QF7351/JT

9<sup>th</sup> December 2014

**Re: 11 Fitzroy Square – Additional Condenser within Front Vault**

**LOWER GROUND FLOOR VENTILATION LAYOUT**

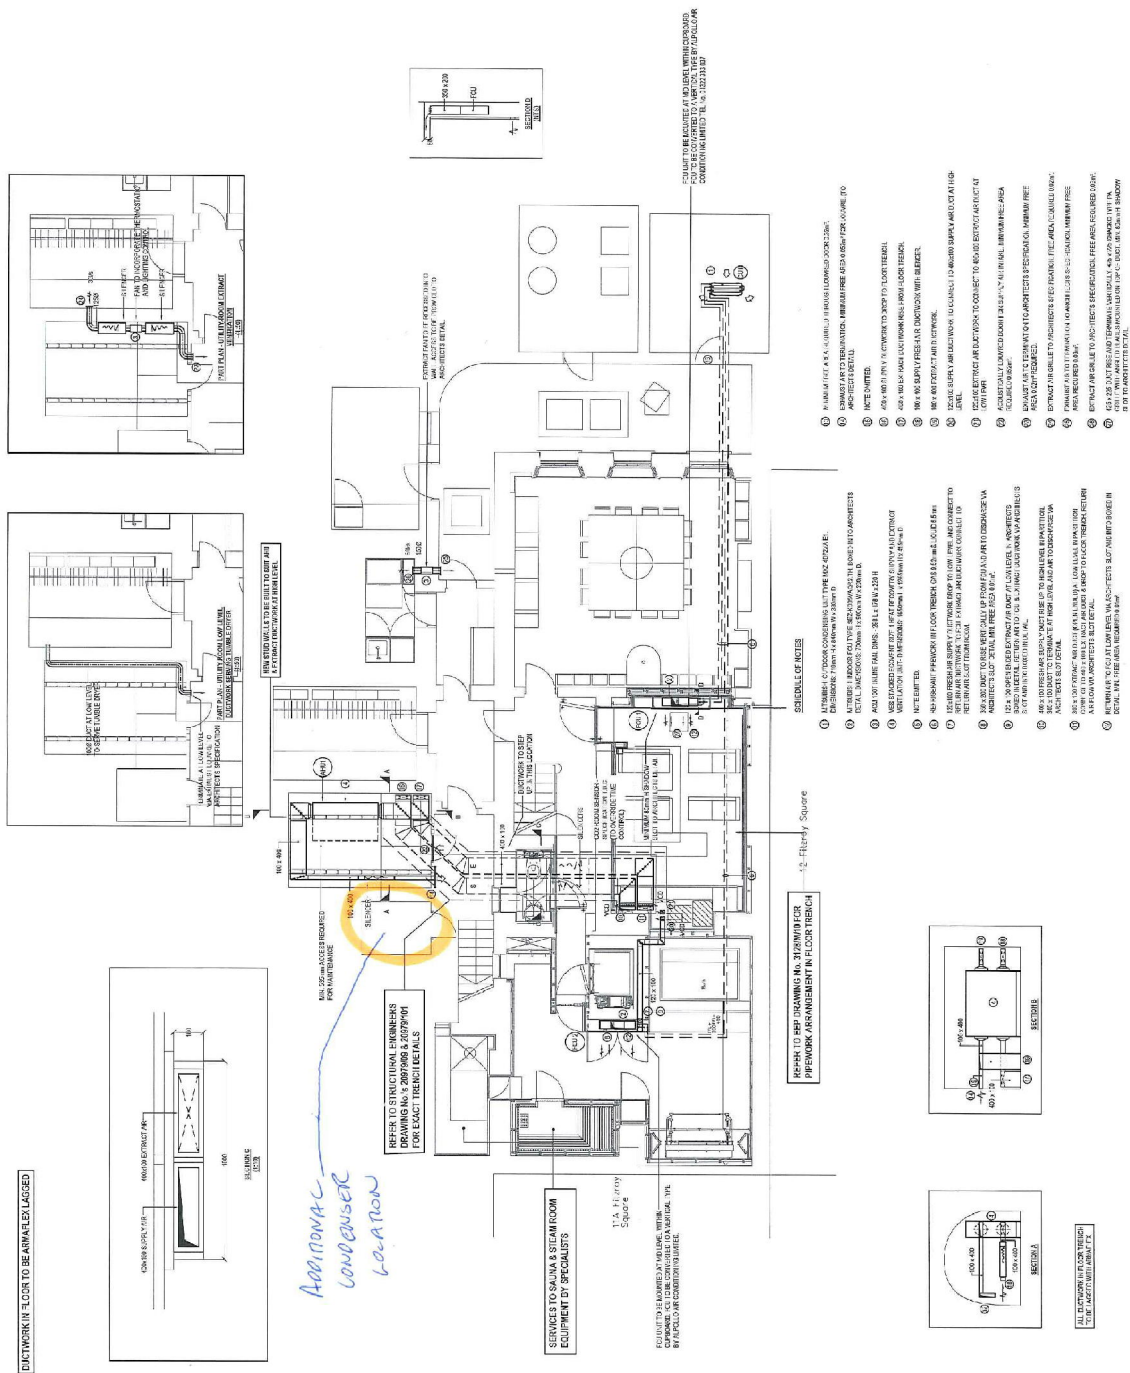
Since the issue of our acoustic report reference QF7351/PF4765/RP1, we acknowledge your request to comment upon the noise impact of an additional condenser installed within a vault at the front at the house. The attached plan has been marked to show the location of the vault, and the attached extract from Fujitsu provides sound power levels of the AOYG14LALL unit proposed.

Within the small vault in which it is proposed to be located, we predict this will result in a reverberant sound pressure level inside the vault in the order of 65dBA.

The vault has a massive construction, so the vault walls will be sufficient to contain all of the condenser's noise. However, we understand that you propose to ventilate the vault via a louvre door set into the front wall of the vault.

Assuming the louvre door has an approximate dimension of 0.9m x 1.8m, then we can use the following formula to predict the effective sound power of the louvre door:

This reveals the louvre door will have the equivalent sound power,  $L_w$ , in the order of of 61dBA.

we can predict that plant noise levels at 1 metre external to the nearest affected residential window, approximately 8 metres away, will be in the order of 38dBA.

As 38dBA is less than the recommended design noise limit of 41.6dBA, it is predicted that the introduction of a the above specified condenser should attract no justifiable complaints under the guidelines set out in Camden's planning policies and as such reservations are not expected from the planning authority on the grounds of noise.

Using acoustic louvres in lieu of non-acoustic louvres would provide an additional reduction in noise and allow a margin for error in our above calculations.

As with any arrangement of plant as described above, we would recommend consultation with the condenser manufacturer to ensure the fresh air and exhaust air paths allow for efficient operation of the machinery.
